PLAN AND ZONING COMMISSION MEETING

CITY OF DAVENPORT, IOWA

TUESDAY, OCTOBER 1, 2019; 5:00 PM

REGULAR MEETING AGENDA

Revised Final Plat

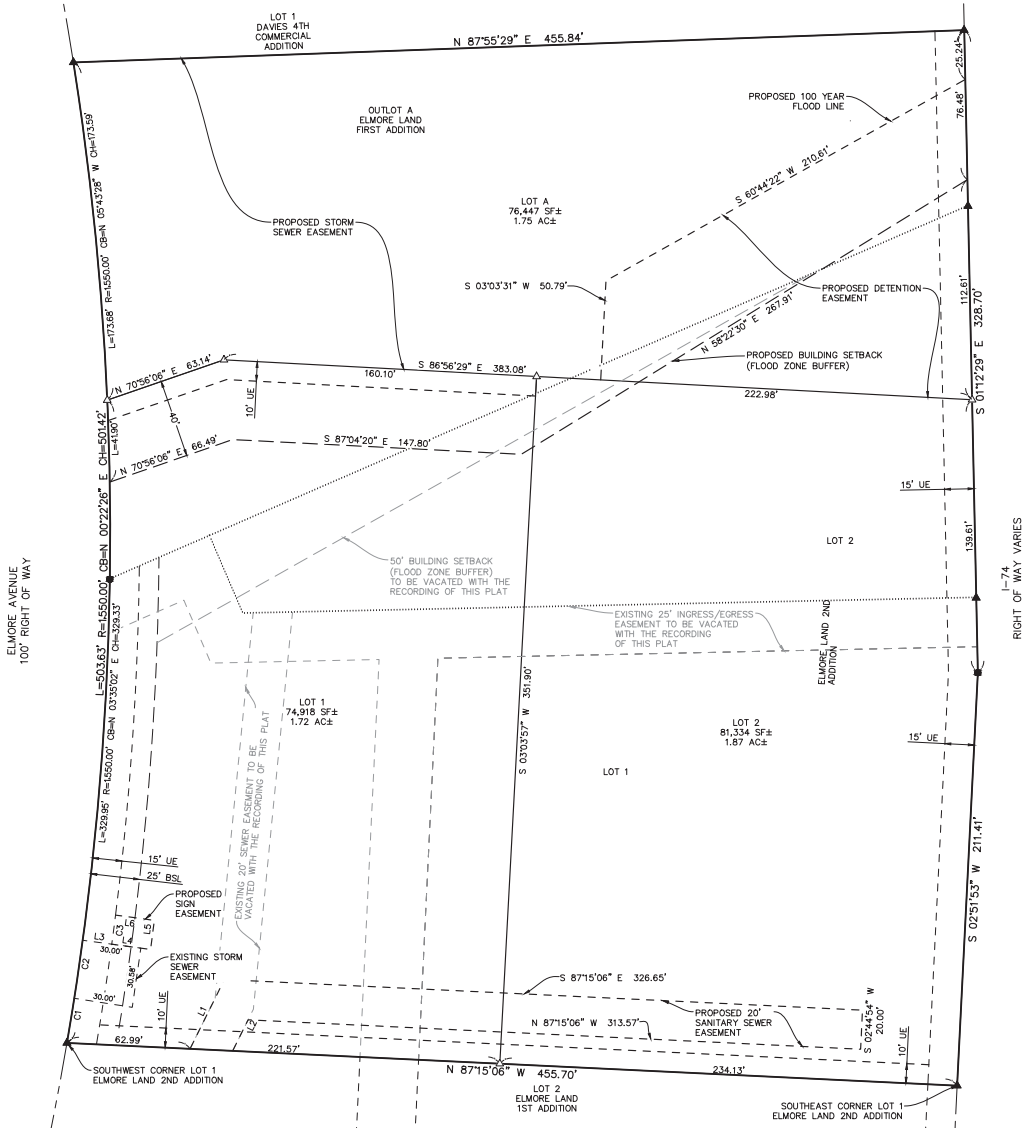
1. That the surveyor signs the plat;
2. That the utility providers sign the plat when their easement needs have been met;
3. That the 100-year flood line be revised as the Estimated Base Flood Elevation. In the general notes provide that BFE and what elevation datum is being used;
4. That the ownership and maintenance of Lot A be shown on the plat; and
5. That the proposed sign easement be removed from the plat.
